CRITICAL AREAS DETERMINATION

NOTICE OF DECISION

Project Number:	CAO17-009
Description:	Request to reduce a Type II watercourse buffer to 25 feet and reduce Category IV wetland buffer to 25 feet in order to accommodate a new Single Family Residence.
Applicant:	Jim Dearth Ripple Design Studio, Inc. 4303 Stone Way N Seattle WA 98103
Owner:	New Horizon Real Estate Development 8744 126 th Ave NE Kirkland WA 98033
Site Address:	8375 E Mercer Way, Mercer Island WA 98040; Identified by King County Assessor tax parcel number 032110-0145
Zoning District:	R-8.4
SEPA Compliance:	The proposal is categorically exempt from SEPA review per WAC 197-11-800(6)(e).
Exhibits:	<ol style="list-style-type: none">1. Development Application for a Critical Area Determination, signed June 19, 20172. Critical Area Study prepared by Evergreen Aquatic Resource Consultants, LLC dated June 22, 2017, revised November 9, 20173. Revised mitigation Plan prepared by Evergreen Aquatic Resource Consultants, LLC dated June 22, 2017, revised November 9, 20174. Peer review memo prepared by ESA, dated October 10, 20175. Public comment letters<ol style="list-style-type: none">a. Karen Walter, Muckleshoot Tribeb. Louise Hasl

PLANTING PLAN, SPECIFICATIONS, AND DETAILS

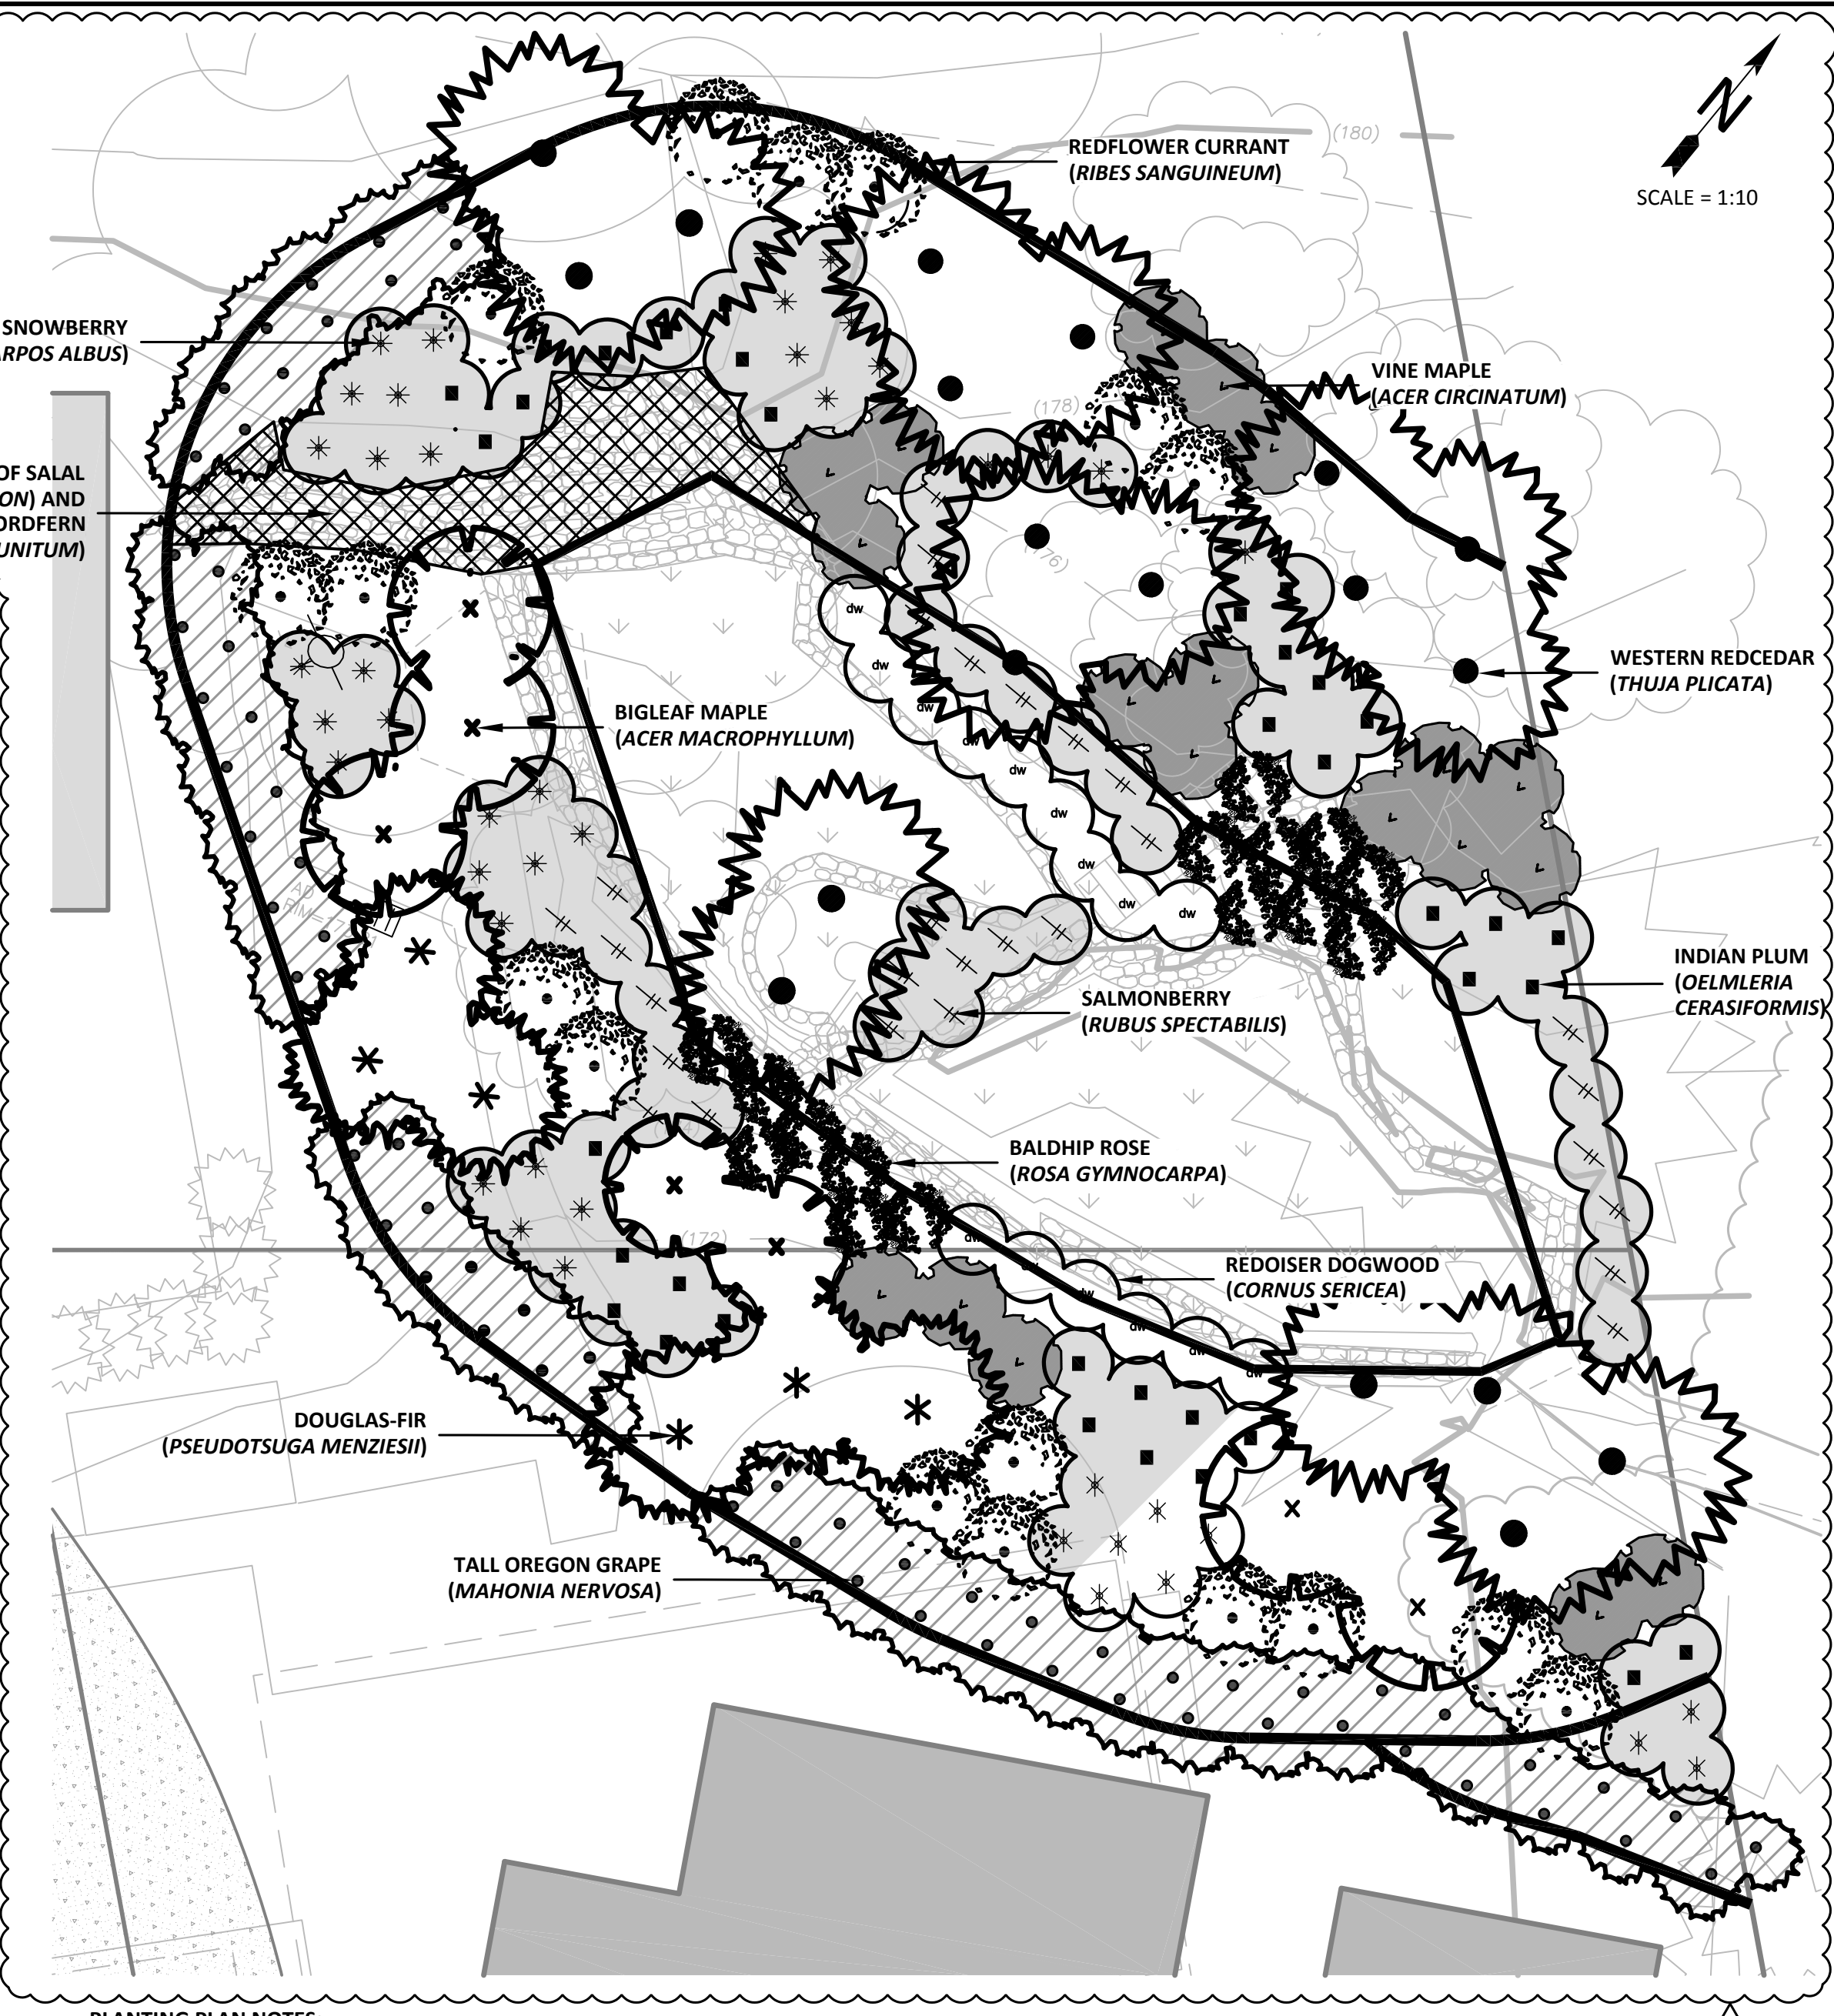
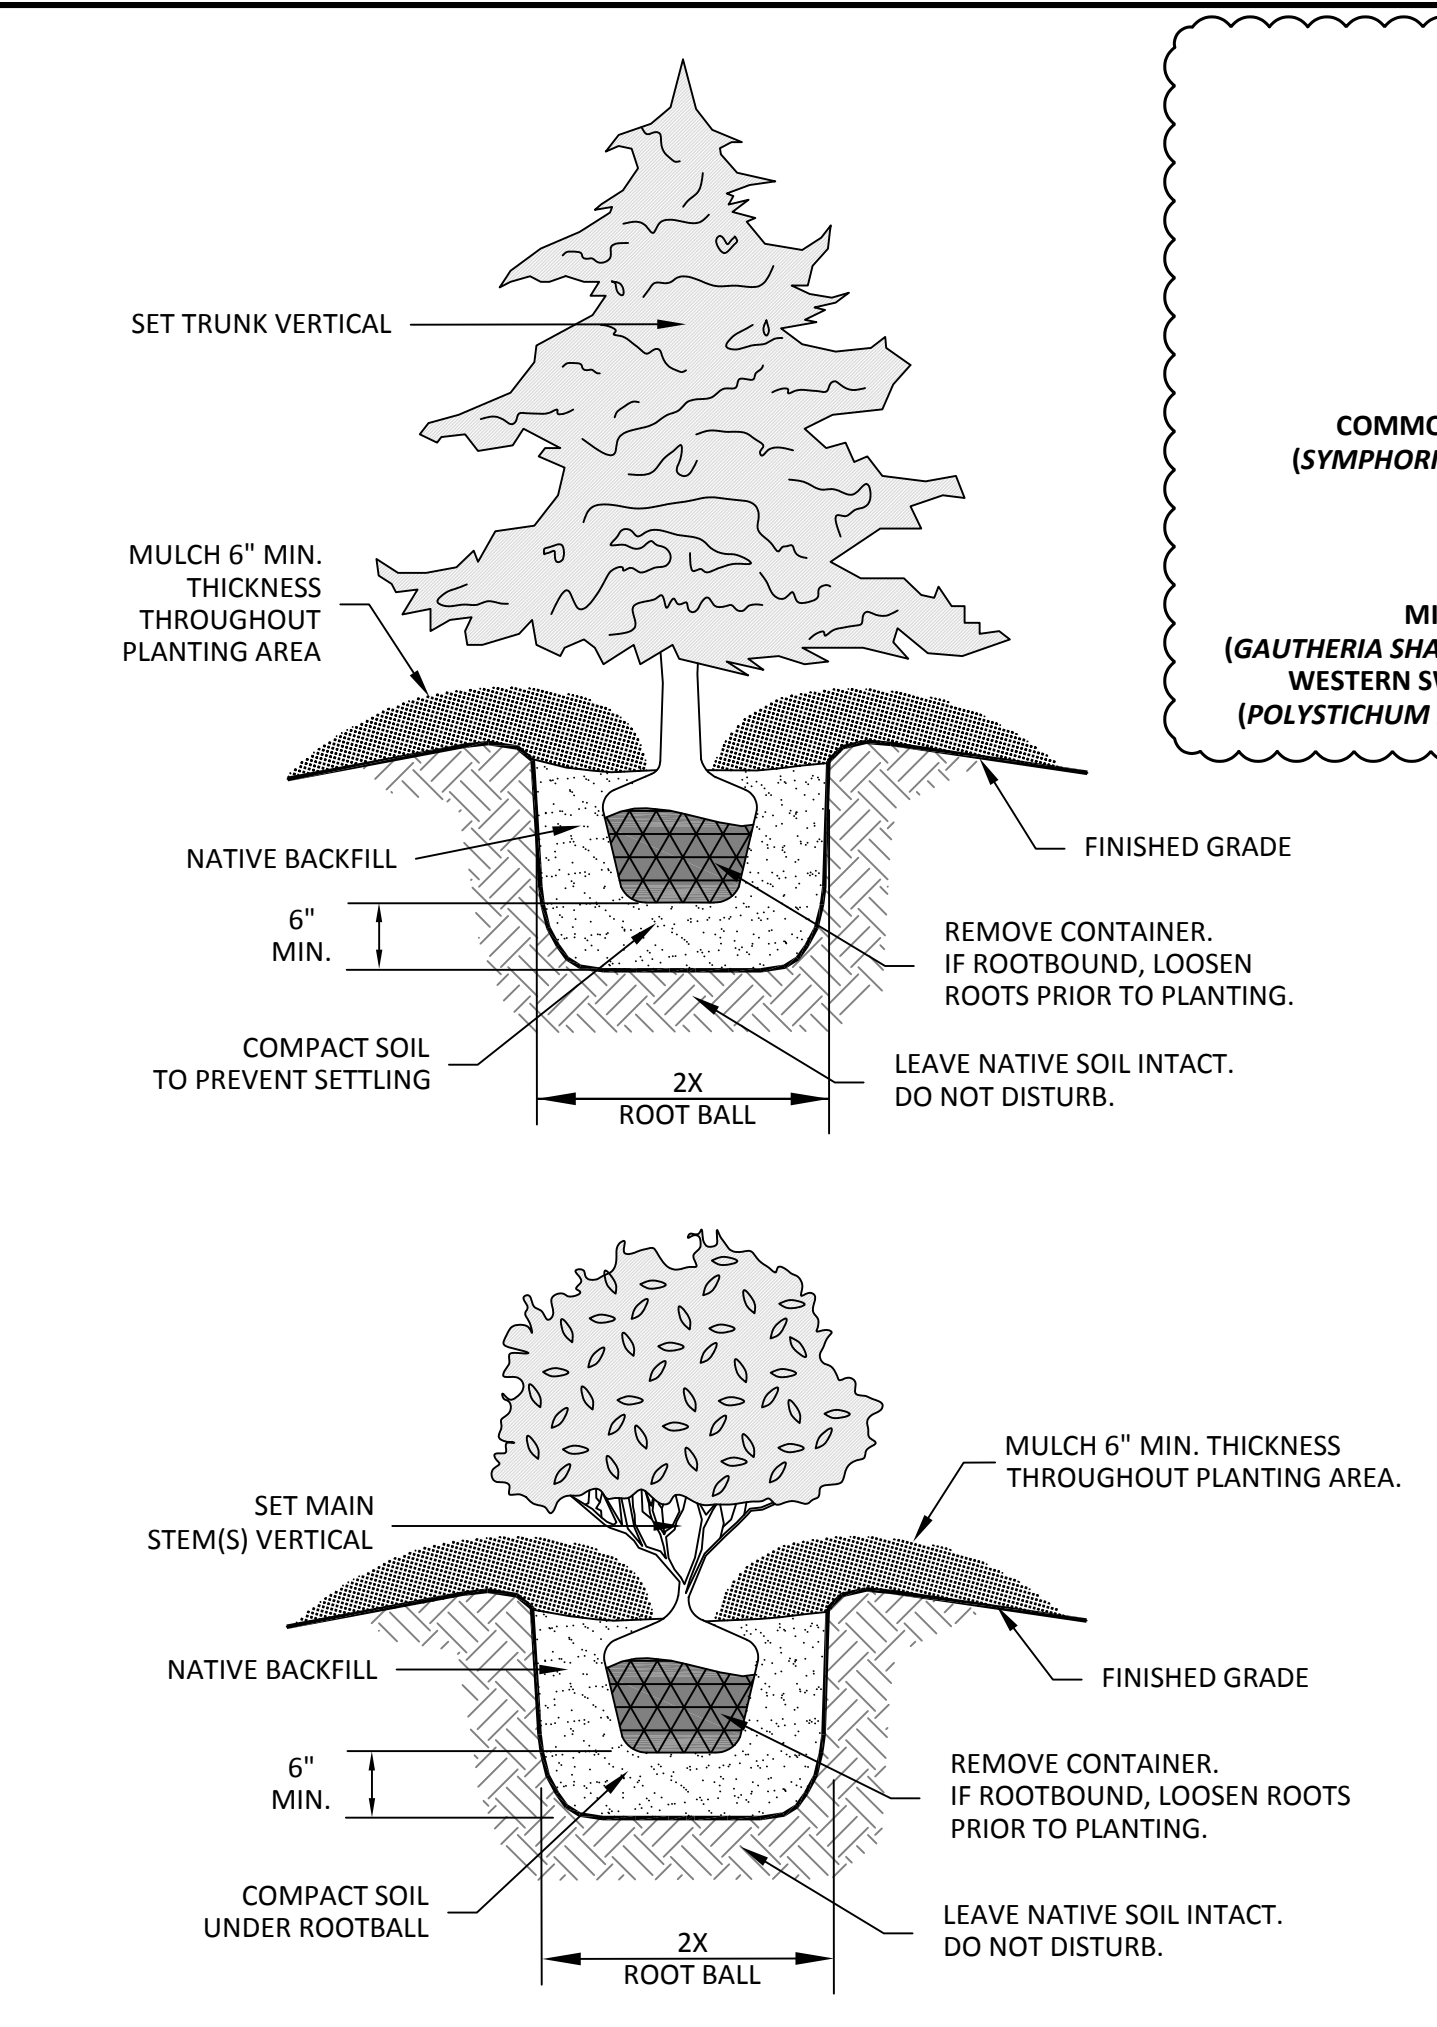
- Seeps located outside of the wetland boundary should be identified and data or rationale provided to justify non-wetland conditions within these areas.
- Increase tree spacing to at least 8 feet apart to provide adequate area for trees to grow.
- Remove blackberry and other invasive species from wetland or wetland boundary by hand to ensure buffer enhancement success.

- b) Increase tree spacing to at least 8 feet apart.

Response: The planting plan has been revised to show a minimum tree spacing of 8 feet and the plant schedule has been revised to require a minimum tree spacing of 8 feet.

PHOTO 2

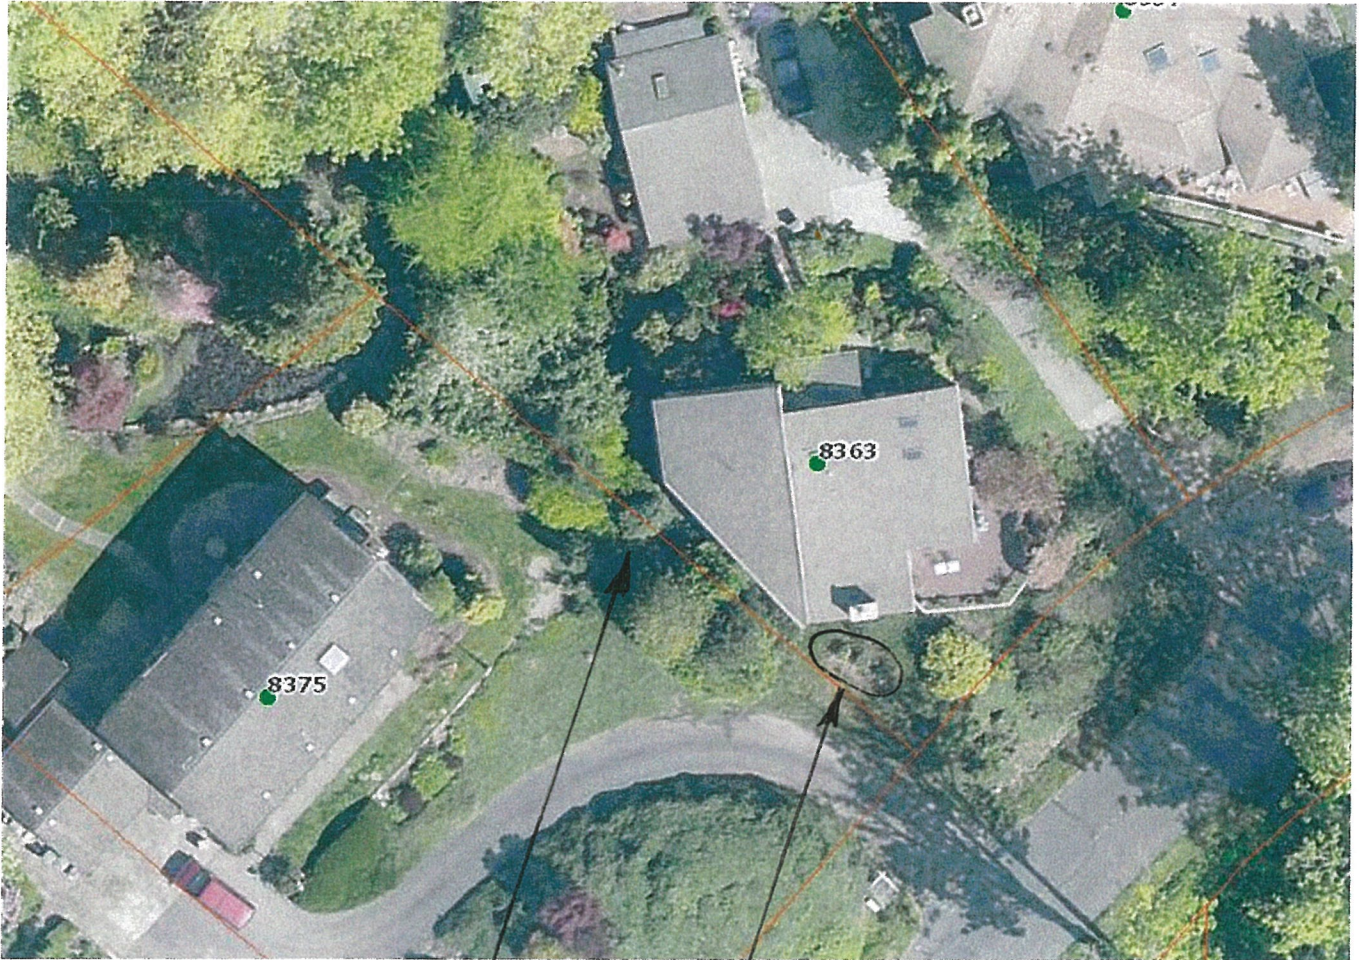
- 2) In anticipation of a development at 8375 E Mercer Way, I have planted four cherry laurels near the crest of the slope on my property along the property line as a privacy shield. These cherry laurels were planted after the Arborist's Field Examination on August 29, 2014 and therefore do not appear in that document. They do, however, show up on the King county GIS map. (Photo 2). I request that the developer respect and protect these laurels during the re-grade of Parcel 1.

Response: *The mitigation plan has been revised to retain all cherry laurels that are rooted on the Shantz parcel.*

MAP B

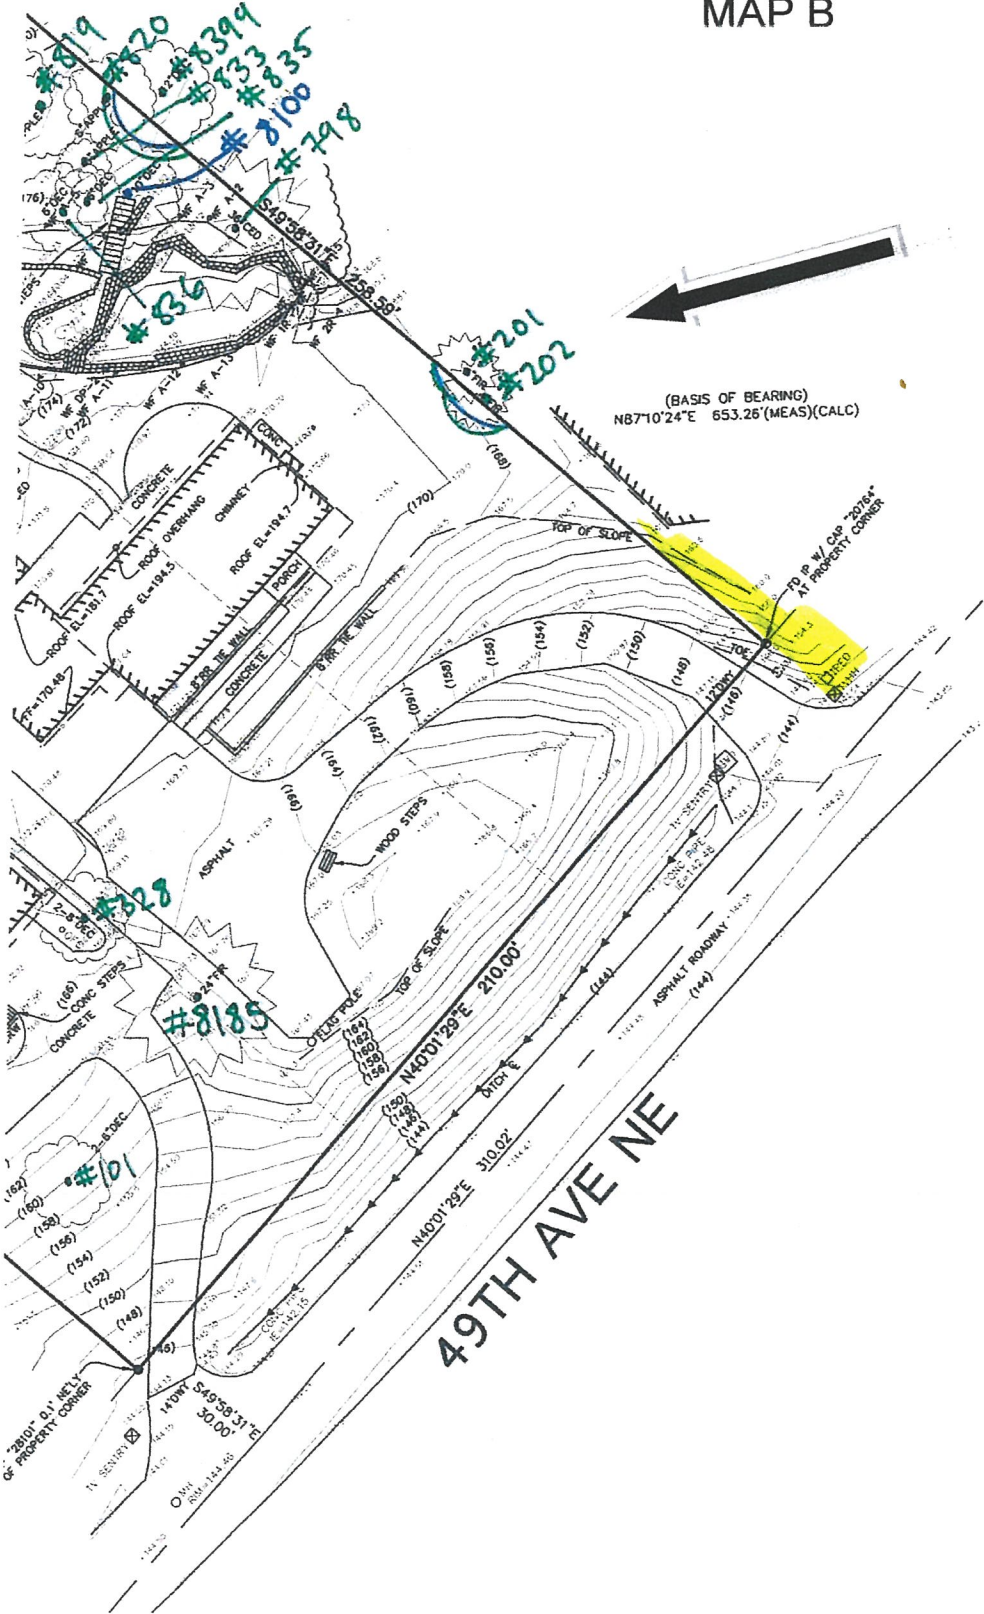
4) There are two live Douglas-fir trees on my property very near the line between Parcel 1 and my property. These trees are described in the arborist's report as tree 201 and tree 202 on Map B. The drip lines of these trees extend into Parcel 1 and are very close to the corner of the residence planned for Parcel 1. I request that particular care be taken for the viability of these trees during excavation and the construction of the new residence.

Figure 1 – Mercer Island GIS Map Showing Stream Gradients

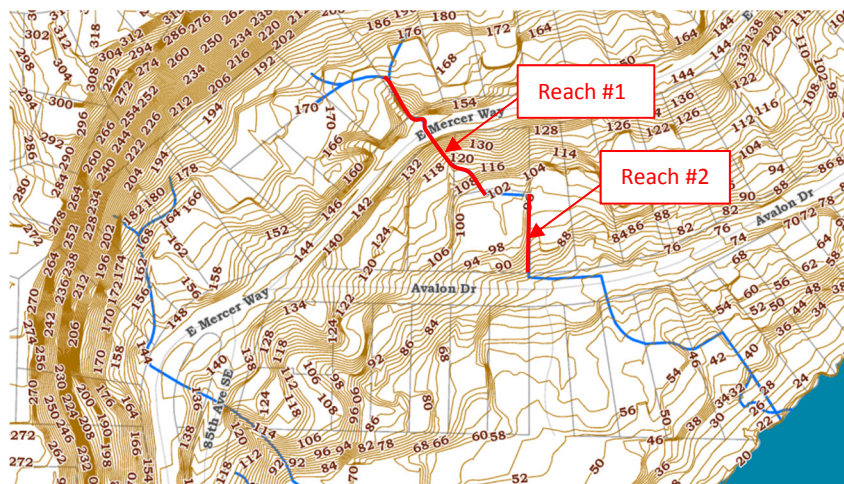
1. The 8375 and 8383 East Mercer Way, Wetland and Watercourse Delineation Study incorrectly identifies a 16% gradient as a complete barrier to fish passage. Per WAC 222-16-031, presumed fish habitat includes streambed gradients up to 20% and the data used for this rule documented resident trout at gradients up to 30%. For this project, the applicant consultants need to provide their data determination to verify that the stream gradients are greater than 20% for a considerable length to correctly call this stream a non-fish habitat stream. They should be using WAC 222-16-031 and the WA Forest Practices Board Manual as part of this analysis.

1. Karen Walter - Muckleshoot Indian Tribe Fisheries Division (September 13, 2017 @ 2:59:07PM)
 1. Additional data regarding stream gradient.

Response: Total stream length is approximately 1,250 feet. There are two stream reaches that exceed a 20% gradient for a total of 253 feet, or 28% of total stream length. Figure 1 shows the location, length, and average gradient for the stream reaches used to determine the watercourse as non-fish bearing. The non-fish bearing determination is consistent with prior City of Mercer Island critical area mapping and supported by recent determinations made regarding the project by City of Mercer Island peer review consultants.

Figure 2 – Location of Wetland Seeps within Wetland A

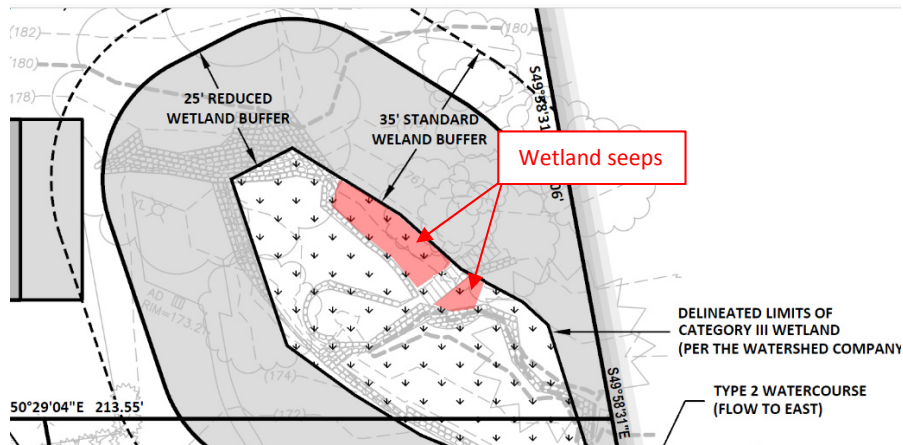
- a) Location of seeps within Wetland A.

Response: *Wetland seeps are located on the north side of Wetland A between the permanent pond and the delineated wetland limits. Figure 2 shows the location of seeps within Wetland A.*
